## DEVELOPMENT REVIEW APPLICATION

For Office Use Only		
STAFF CONTACT <b>Jennifer Arnold</b>	PROJECT No(s). <b>DR-20-07/VAR-20-02/WAP-20-03</b>	
NON-REFUNDABLE FEE(S) <b>\$825</b>	REFUNDABLE DEPOSIT(S) <b>\$21,850.00</b>	TOTAL <b>\$22,675.00</b>

<b>Site Location/Address:</b> <b>5665 AND 5639 HOOD STREET, WEST LINN, OR 97068</b>	Assessor's Map No.: <b>22E30CA</b>
	Tax Lot(s): 00700 AND PORT 00900
	Total Land Area: <b>1.01 AC</b>

**Brief Description of Proposal: DEMOLITION OF EXISTING BUILDING AND PARKING AREA. BUILD NEW POST OFFICE BUILDING OR RETAIL BUILDING WITH A SHARED PARKING AREA.**

SHEET  
**P301-B**  
JOB NO.  
2838-001

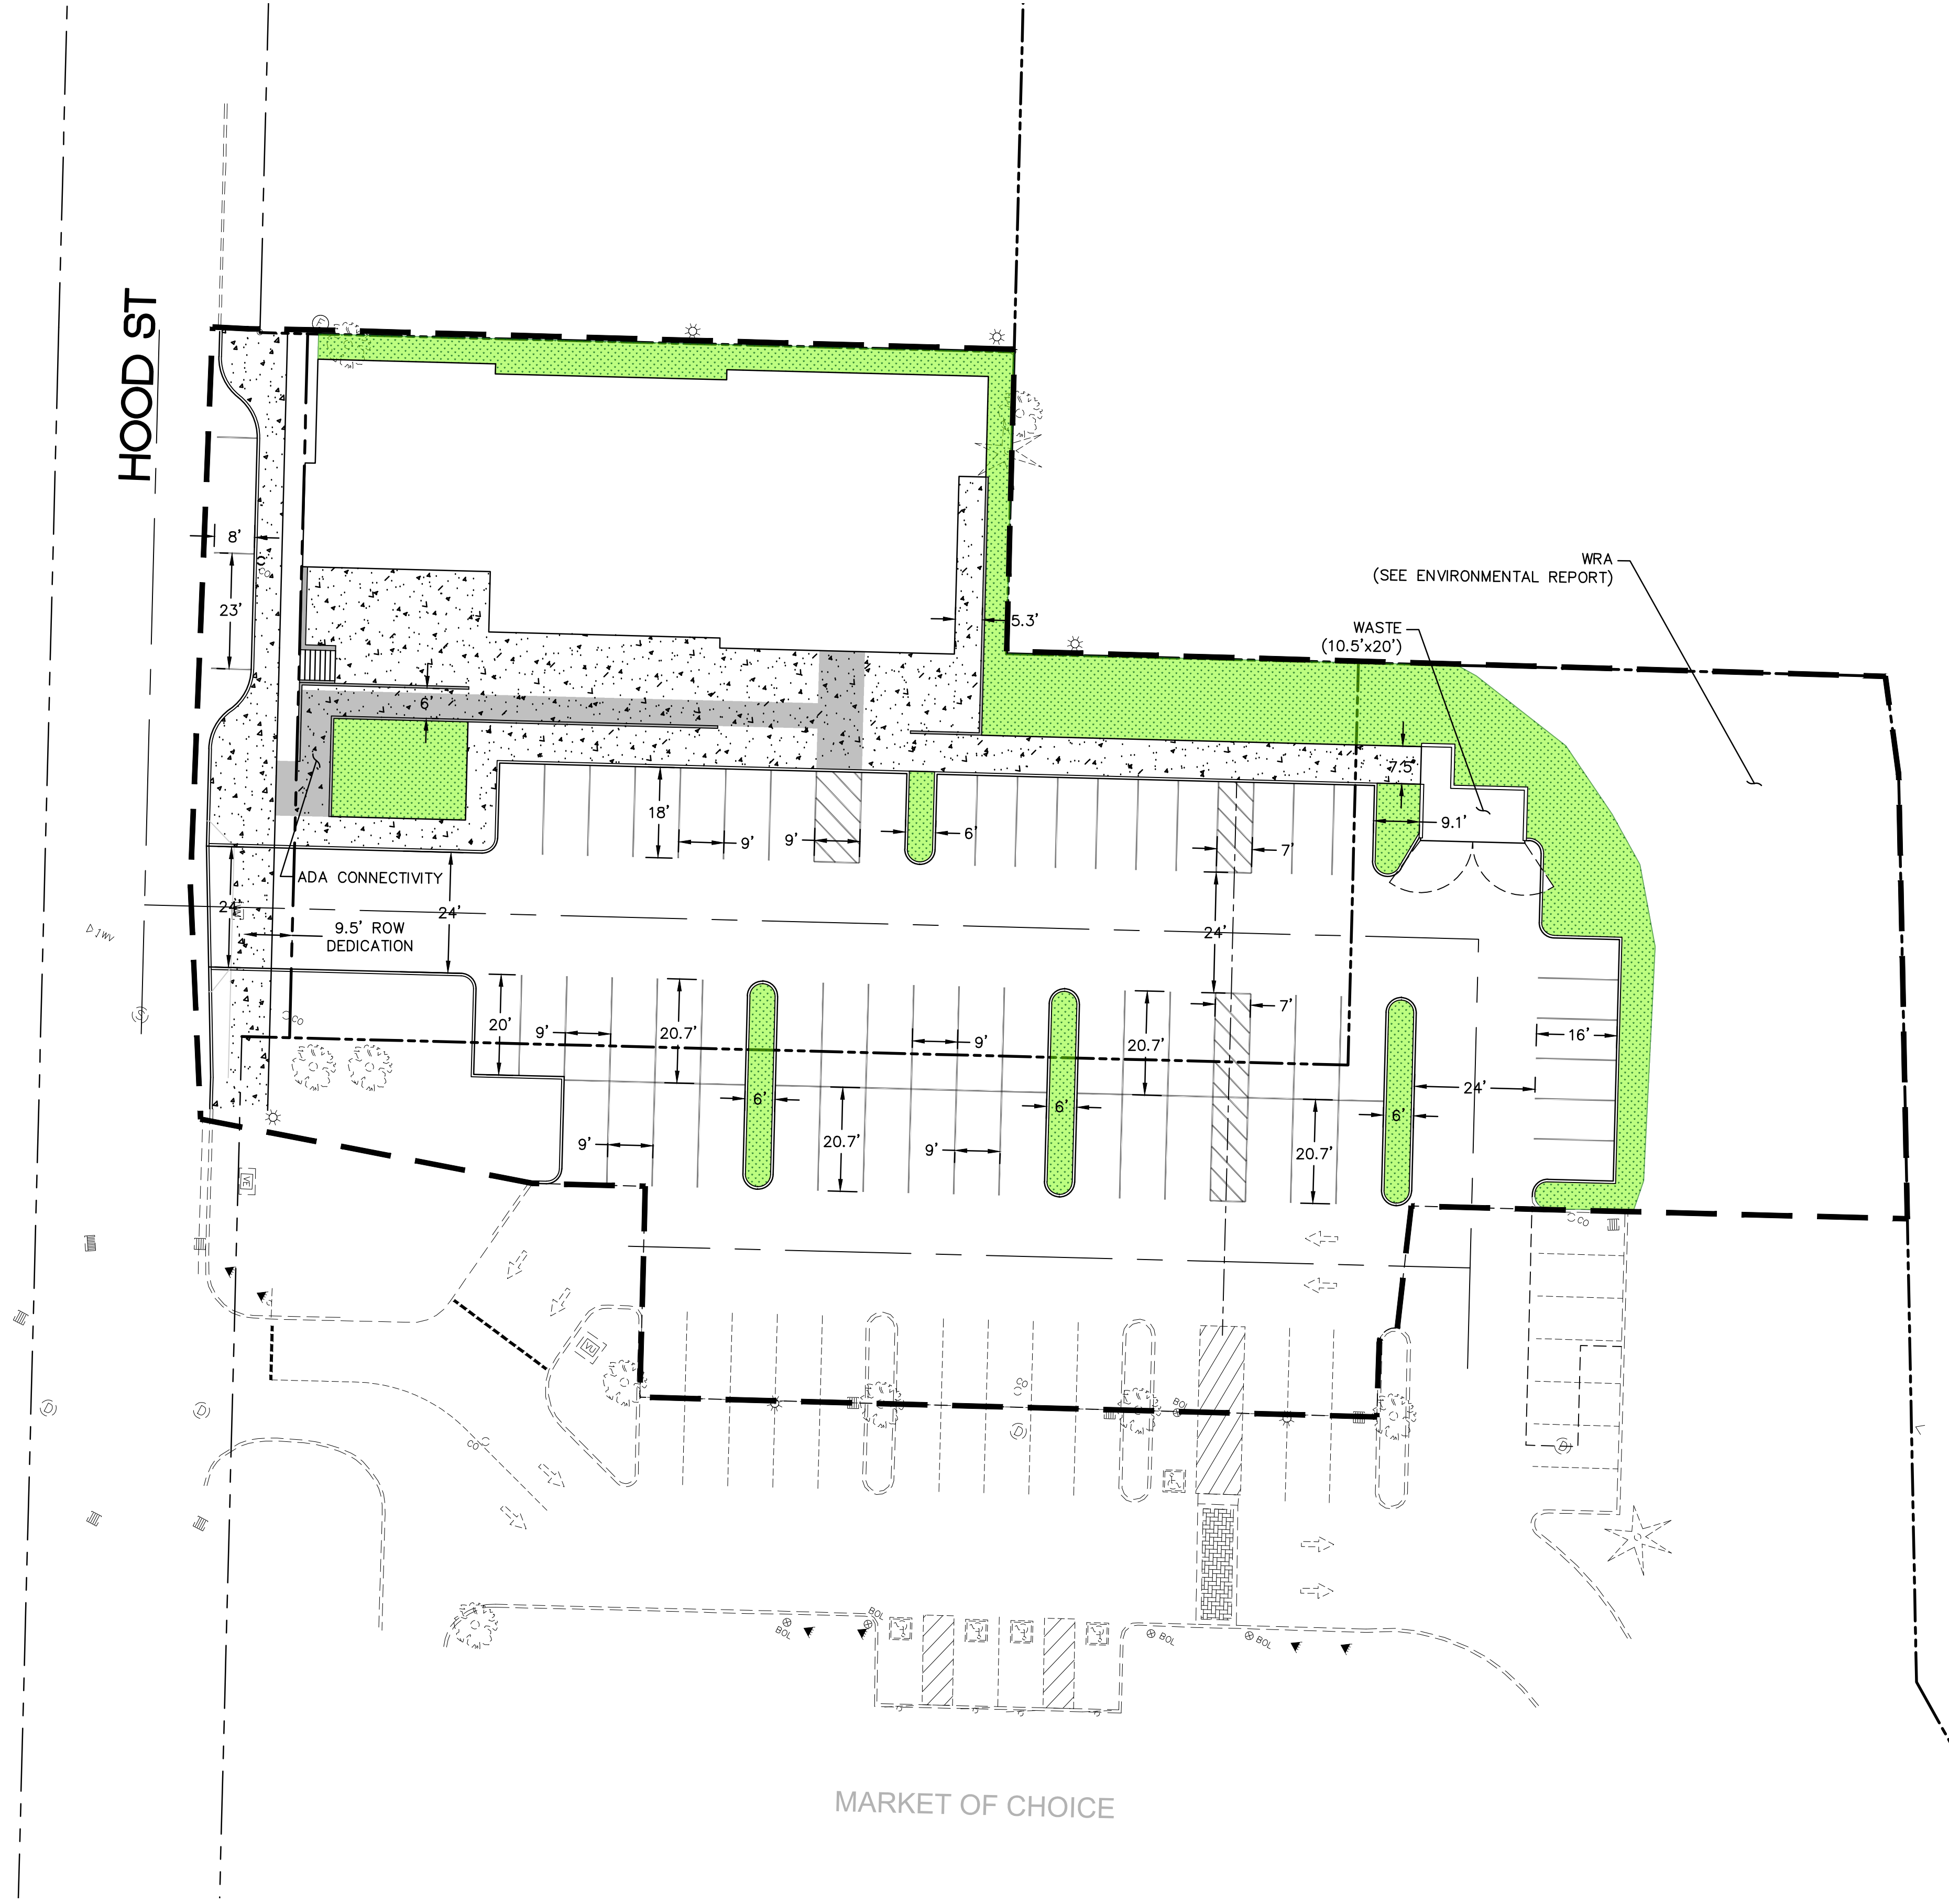
**1. *Plans showing the off-site street improvements. Street improvements should be designed to continue the streetscape along Hood Street with parallel on street parking and sidewalks.***

**Response:** Option "A" contains limited street frontage to accommodate parallel parking due to the shared truck loading and customer drive through lanes. The distance between the two access points is roughly 62 feet, which when accommodating for transitions for parking would only yield 2 spaces. In addition, the required vision clearance triangles reduce this potential parking area down to one space. Based on this safety requirement, it is proposed to construct a wider than 6-foot sidewalk along this portion of the street frontage.

Option "B" does not contain the shared truck loading and drive through lane configuration and can accommodate parallel parking in addition to the sidewalk, as shown on the revised plans. Enclosed is an updated Option "B" site plan set.
